TECHNICAL INFORMATION

No: 12/01/99/NAS
 Ref: Alert SA99 1201
 Issue: 2
 Date: 06/04/99

Sump Bolt Oil Seep

SUMP BOLT OIL SEEP ON 1999 "THOR" V8 ENGINES

Figure 1

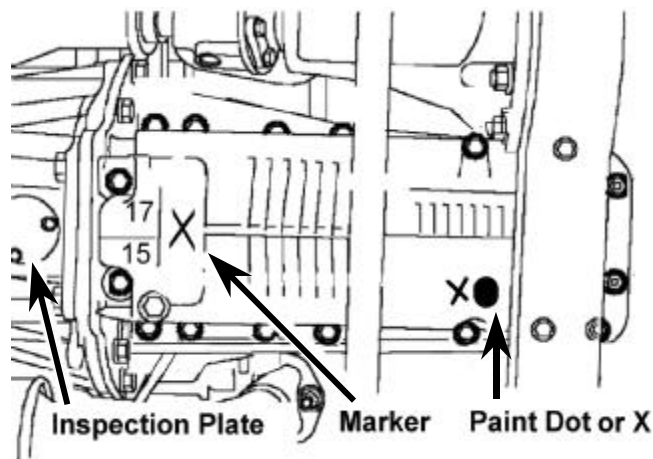
The two rear most structural sump bolts that thread into the rear main bearing cap may be the source of an oil leak on some 99 MY "THOR" V8 engines. (Positions 15 and 17 in Figure 1) Vehicles produced with engines after the above engine number, or vehicles marked by Land Rover on the engine sump, have had the condition corrected.

- At PDI inspect engine sump for any markings indicating that a prior repair has been completed on vehicles before the safe engine numbers. (Figure 1)
 - "X" with marker pen just in front of bolts 15 and 17 indicates a line repair.
 - A yellow or blue paint dot or "X" at the front of the sump indicates a repair completed at engine assembly.
- At PDI if the sump is *not* marked and the vehicle is before the safe VIN, perform the following procedure and claim SRO 12.60.89/36.
- If a leak from the specified sump bolts has been detected after vehicle delivery, perform the following procedure and claim SRO 12.60.89/34 which includes drive-in/drive-out plus diagnostic time.

- Remove **one** bolt (Figure 1 - #15 or #17) and clean thoroughly.
- Clean the bearing cap threads and the sump casting of all oil.

- Apply a small amount of Permatex/Loctite "THE RIGHT STUFF" ® to the underside of the bolt head.
- Install treated bolt and torque to **22 Nm (16 lbf. ft.)**.
- Remove second bolt and repeat steps 1 through 4 for that bolt.
- Verify that entire sump bolt area is clean and free of all oil and oil residue.
- Mark the sump with an "X" near the sealed bolts as indicated in Figure 1.
- Start engine and check for oil leaks.
